**Apple No. 10/796,597**  
**Amdt date July 16, 2007**  
**Reply to Office action of April 16, 2007**

**Amendments to the Drawings:**

### **REMARKS/ARGUMENTS**

FIG. 1  
(PRIOR ART)

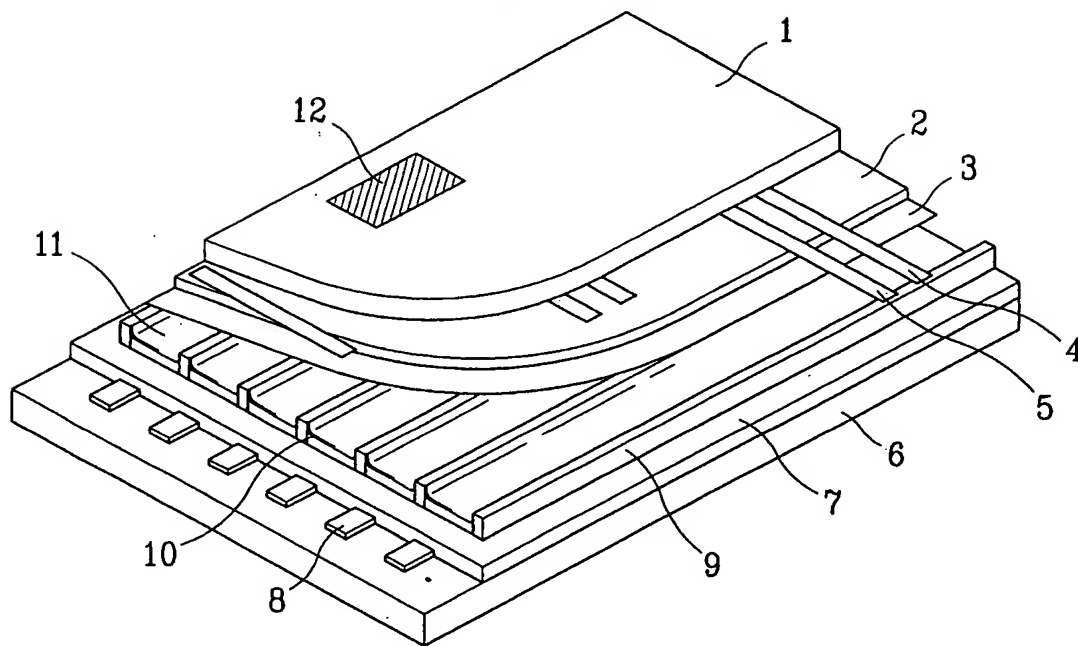
Figures 1, 2 and 3 are objected to for not including the legend "Prior Art." Figures 1, 2 and 3 are being amended to include the legend "Prior Art." Applicants submit herewith corrected drawing sheets together with annotated drawing sheets. As such, Applicants request that the objection to the drawings be withdrawn.

The attached sheets of drawings include changes to FIG. 1, FIG. 2 and FIG. 3 and replace the original sheets including FIG. 1, FIG. 2, FIG. 3 and FIG. 4. .
